Planning Board Meeting Minutes

December 14, 2023

Re: Site Plan Application Review
Proposed 48-unit apartment project
7235 N. Central Ave

Re: Site Plan Application Review
Proposed 48-unit Apartment Project
7235 N. Central Ave.
File No. 331.015

6 DUMPSTER PAD AND ENCLOSURE
C-7 SCALE NTS

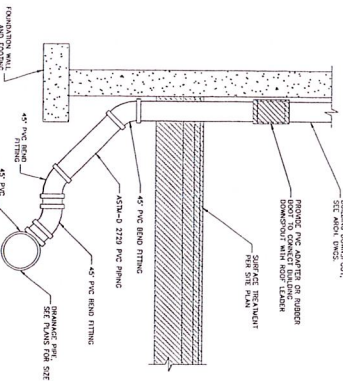
- 1) Detail #6: The dumpster enclosure is proposed as a 7' high chain link fence. If the Planning Board desires better screening of the refuse collection area, I suggest this be reviewed with the applicant.

3 POCKET POND CROSS SECTION
C-9 SCALE: NTS

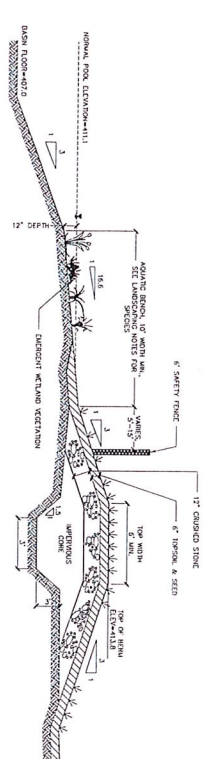
- 1) Detail #3: I suggest the minimum top of berm width be 6' to allow for maintenance access.

Noted, Detail #3 has been revised to specify a minimum berm width of 6'.
